# E C O L O G I C A L   R E V I E W

## **West Lake Boudreaux Shoreline Protection and Marsh Creation**

State No. TE-46

November 8, 2005

Figure 2. Rock dike settlement curves overlay (data from Burns Cooley Dennis, Inc. 2003).

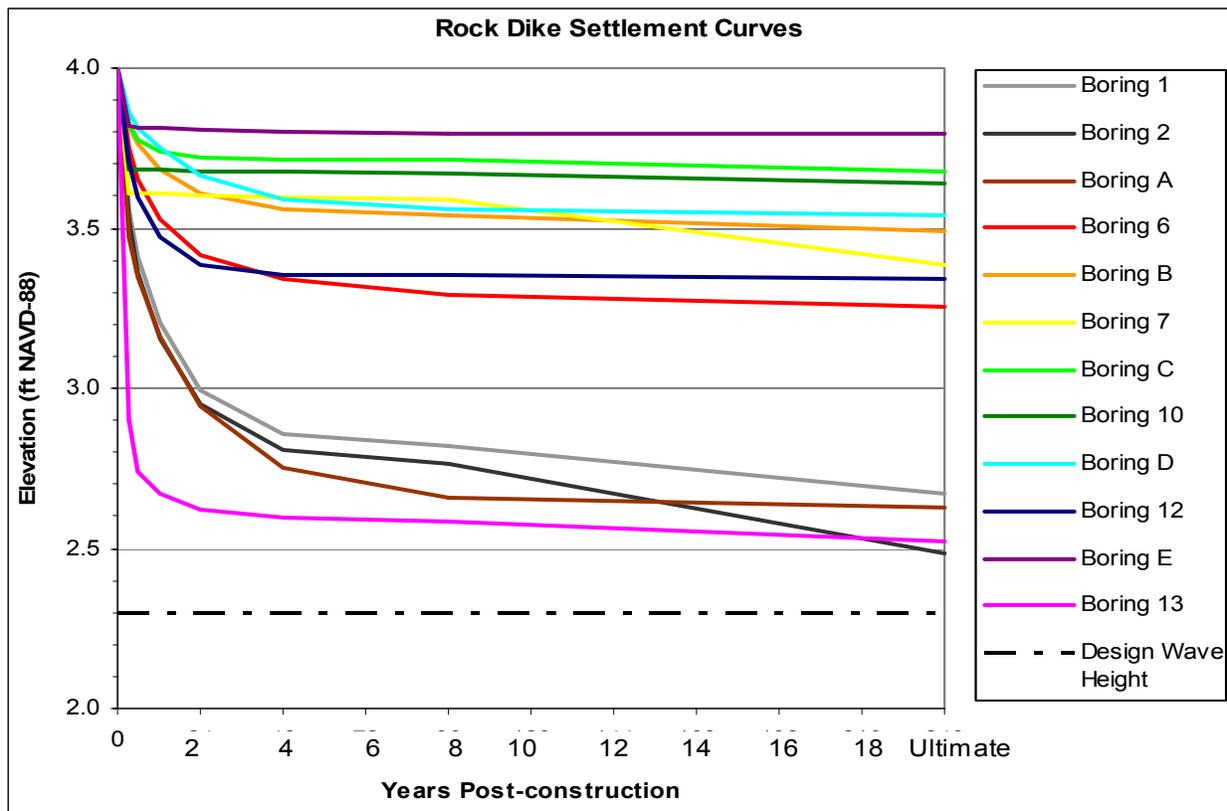
Separate settlement curves were provided in the geotechnical report for individual boring locations based on a rock dike height of +4.0 feet NAVD 88 (Burns Cooley Dennis, Inc. 2003). An aggregated overlay of each of these individual curves is shown in Figure 2 below. A review of the settlement predictions by the project team engineers determined that a dike elevation of +3.5 feet NAVD 88 would provide adequate protection for the design wave height. It should be noted that the settlement predictions do not account for subsidence.

- The geotechnical report evaluated the settlement of the foreshore rock dike constructed to an elevation of +4.0 feet NAVD 88 (Figure 2). Based on the estimates of settlement for 12 individual soil borings, it was determined by project team members that the rock dike could be constructed to an elevation of +3.5 feet NAVD 88 and still provide the desired level of protection for the 20-year project life. Although this seems logical, the analysis fails to take into consideration local subsidence that has been estimated to be 0.43 inches per year (1.09 centimeters per year) or 0.7 feet over 20 years (Penland and Ramsey 1990). Therefore,

maintenance and monitoring efforts should be coordinated to ensure structural stability and functionality over the 20-year project life. It is important to note that subsidence was not accounted for in the design of the rock dike; however, subsidence was acknowledged and accounted for in the marsh creation component of this project.

Figure 3. The details of the (1) rock dike with adjoining earthen containment dike, (2) earthen containment dike only, and (3) rock dike only (USFWS 2005b).

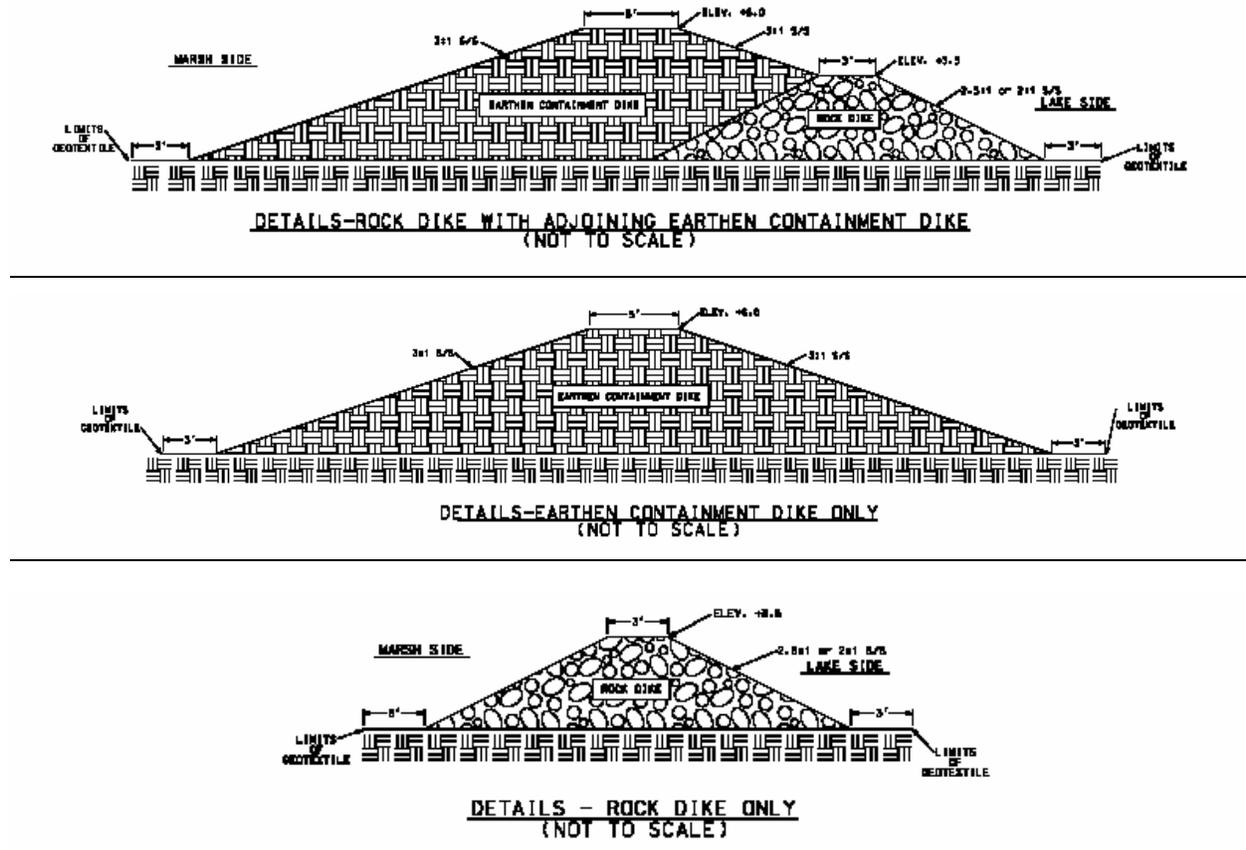
The geotechnical design for the rock dike was evaluated for structural stability relative to wave impacts. A design 70 mile per hour wind was evaluated as per guidance provided by the Louisiana Department of Natural Resources (LDNR)/Natural Resources Conservation Service (NRCS) Design Guidelines for Coastal Wetlands Planning, Protection and Restoration Act (CWPPRA) Shoreline Protection Structures (LDNR/NRCS 2000). These guidelines govern rock section geometry and gradation requirements. The side slope, generated by the geotechnical analysis, with a 3.0-foot top width set at an elevation of +3.5 feet NAVD 88 was determined to be adequate (USFWS 2005b). Due to the varying soil properties, the northern segment of the dike will have a 2.5H:1V side slope and the central and southern segments of the dike will have a 2H:1V side

slope (USFWS 2005b). The details of the (1) rock dike with adjoining earthen containment dike, (2) earthen containment dike only, and (3) rock dike only are presented below (Figure 3).

Figure 4. Dredge fill settlement curves overlays (data from Burns Cooley Dennis, Inc. 2003).

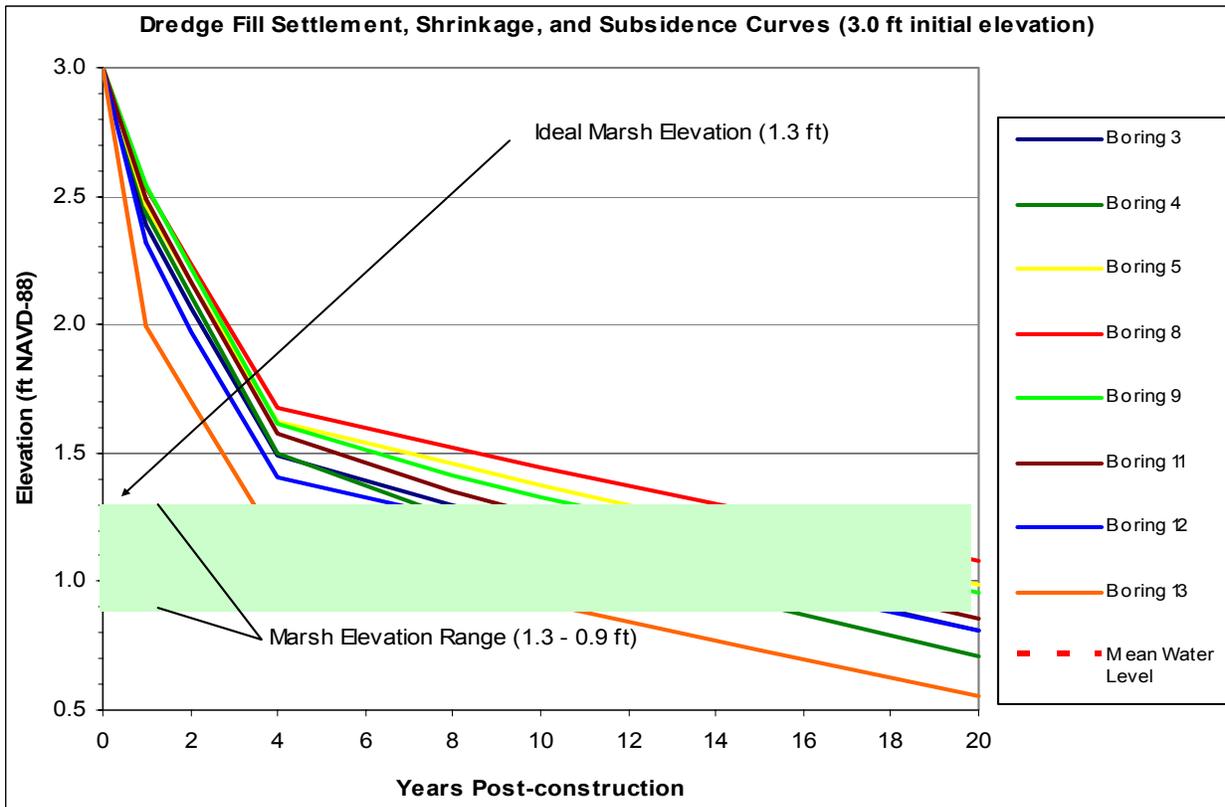
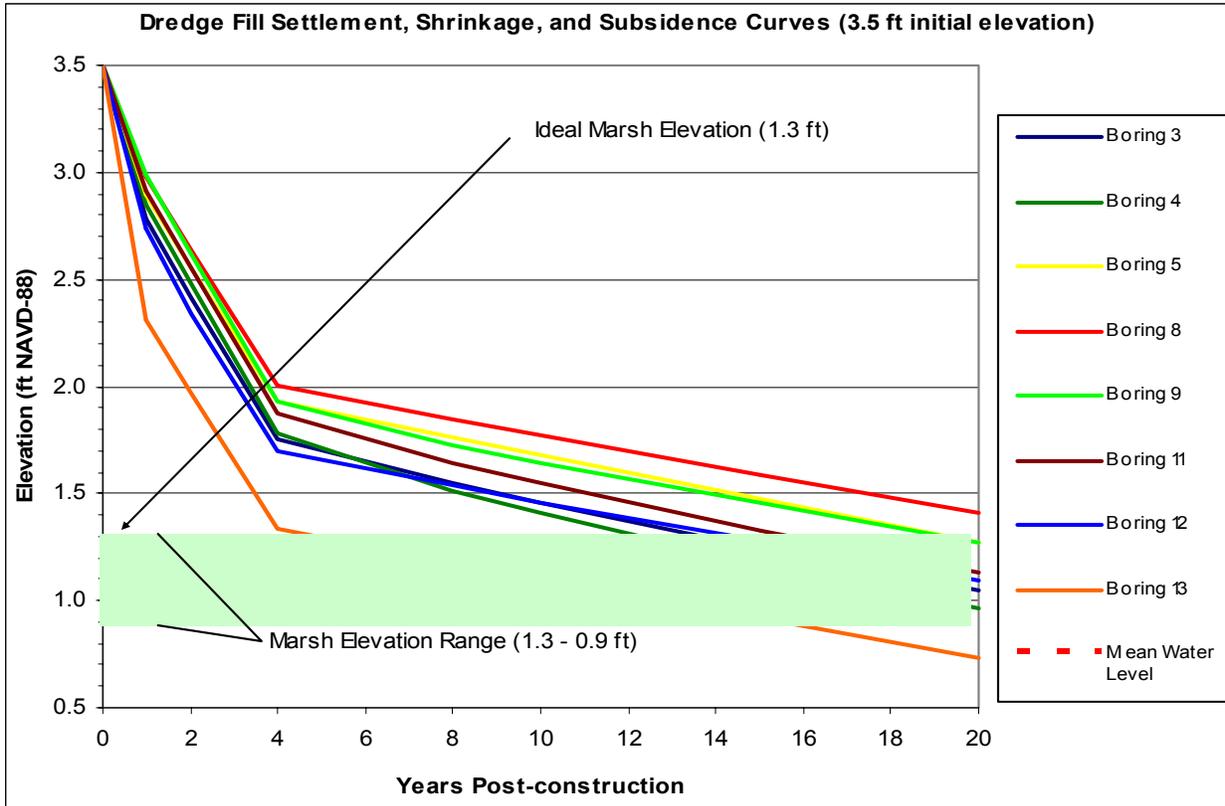
+2.5 feet NAVD 88. However, in an effort to account for subsidence, the fill height was increased by 0.7 feet, which equates to a subsidence rate of 1.09 centimeters per year (0.43 inches per year) based on estimates calculated by Penland and Ramsey (1990), yielding a subsidence-adjusted fill height of +3.2 feet NAVD 88. The settlement curves, as reproduced from the geotechnical report by Burns Cooley Dennis, Inc. (2003), were based on fill heights of +3.5 feet NAVD 88 and +3.0 feet NAVD 88 (Figure 4). The resultant marsh elevations projected over the 20 year project life based on a fill height of +3.2 feet NAVD 88 may be visually approximated by viewing both components of Figure 4. By accounting for settlement, shrinkage, and subsidence, it appears that this design will yield marsh in a desirable elevation range throughout most of the project life.
